MILITARY SPECIFICATION

MICROCIRCUITS, DIGITAL, BIPOLAR, ADVANCED SCHOTTKY TTL, 8-BIT IDENTITY COMPARATOR, MONOLITHIC SILICON

This amendment forms a part of MIL-M-38510/347, dated 1 May 1985, and is approved for use by all Departments and Agencies of the Department of Defense.

FIGURE 4 Burn-in and life test circuit - Continued.

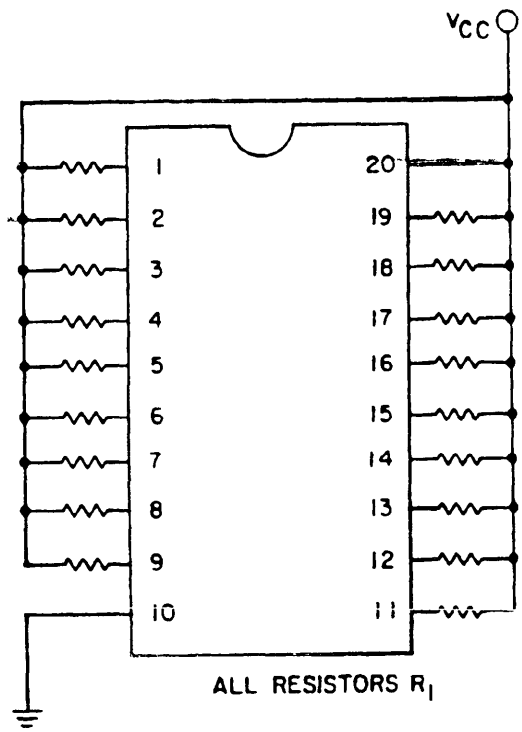
* 4.2.a.(1): Delete "D or E" and substitute "D, E, or F".

* 4.4.3.c.(1): Delete "D or E" and substitute "D, E, or F".

NOTES:
1. High temperature (175°C) condition F burn-in circuit only.
2. R_1 = 2 kΩ.
3. V_{CC} shall be chosen such that 5.0 V minimum is present at device terminal.
